**Decision Maker:**      **Environment Portfolio Holder**

**Date:**                      **15th March 2018**

**Title:**                      **LOWER SYDENHAM TO BROMLEY QUIETWAY PUBLIC  
CONSULTATION REPORT AND FINAL PROPOSALS**

**Worsley Bridge Road shared path-** Implement as proposed with minor modifications based on consultation comments

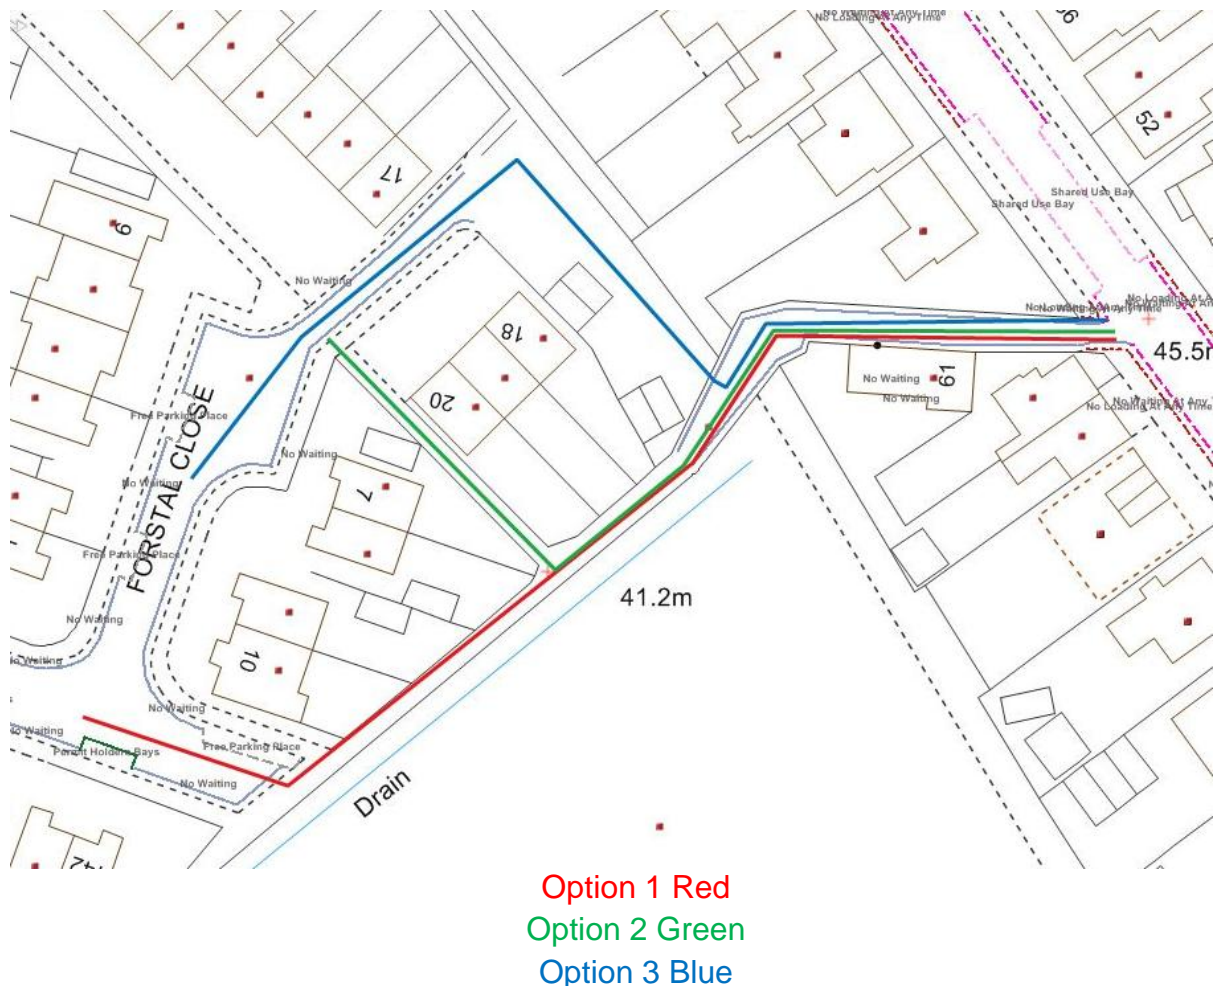
- Given pedestrian flows and amenities along Worsley Bridge Road, a 3m shared path is likely to introduce significant pedestrian-cycle conflicts and represents a poor quality approach. Given the amount of off-street parking, parking reduction should be considered, along with other mechanisms to gain more space for those walking and cycling. In fact, the amount of on-street parking in use on Google Streetview indicates the council could and should be working with businesses and residents here on a car use reduction strategy, as well as potentially car-sharing, car clubs etc.

Worsley Bridge road - Broadly supportive of the widened shared use footway approach, but with strong concerns about the safety of some of the driveways and residential exits where visibility is not good.

Drawing 1 it is not clear who has right of way at crossovers. The raised entry treatments and cycle logos may imply to cyclists that they have right of way. This may cause conflict with vehicles exiting private premises.

Whilst not against the use of a continuous footway I have real concerns about this particular design. Rather than being aligned with the edge of the footway, the continuous footway across Station Approach dips into the mouth of Station Approach, causing cyclists to have to turn into and out of Station Approach to use it. This design ensures that in order to give way to cyclists vehicles have to stop some considerable way into Station Approach and as such it appears from the limited detail on the plan that drivers will have no visibility of oncoming cyclists in either direction. Equally cyclists using this footway on either side of the junction will have no view of vehicles emerging from the junction until they are almost on top of it. There is a considerable amount of foliage on the north side of the junction which further impedes visibility. The problem of visibility is compounded by parked vehicles to the south side of the junction. Drivers heading north wishing to turn left into Station Approach are unlikely to be able to see cyclists also heading north on the footway if there are vehicles parked on the south side of the junction. The plan shows a single yellow line at this point whereas parking needs to be prohibited here at all times. The continuous footway and lack of intervisibility may also cause a problem with shunt collisions in Worsley Bridge Road as drivers stop suddenly to allow priority for a cyclist when turning. This may be made worse if traffic speeds are high. There is a further problem of visibility for drivers heading south in Worsley Bridge Road who wish to turn right into Station Approach. In order to see a cyclist also heading south on the shared footway a driver would have to turn 180 degrees in order to spot a south bound cyclist before turning. The addition of new trees at this junction may also affect intervisibility.

As a result of all of the above issues I object to this part of the design.  
Do you have plans with visibility splays and speed survey results?

I support the addition of the zebra crossing in Worsley Bridge Road provided speed surveys show that the eighty fifth percentile speeds are below 37mph.

The access to the south of the junction with Station Approach has give way markings positioned in a way as to imply that vehicles exiting the access have right of way over pedestrians and cyclists which should not be the case with continuous footway. The engineering should ensure that motorists know that they do not have right of way. This is ambiguous and may lead to pedestrian vehicle conflict and cycle vehicle conflict.

A general concern is the clarity of who has right of way at crossovers. Cycle logos and coloured surface imply that cyclists have right of way but this is ambiguous as there are no give way markings for cyclists or vehicles and it is likely that drivers will not give way to cyclists at these crossovers. This may result in cyclist vehicle conflict at crossovers. Of particular concern are the entrances to industrial units where numerous movements of HGVs take place.
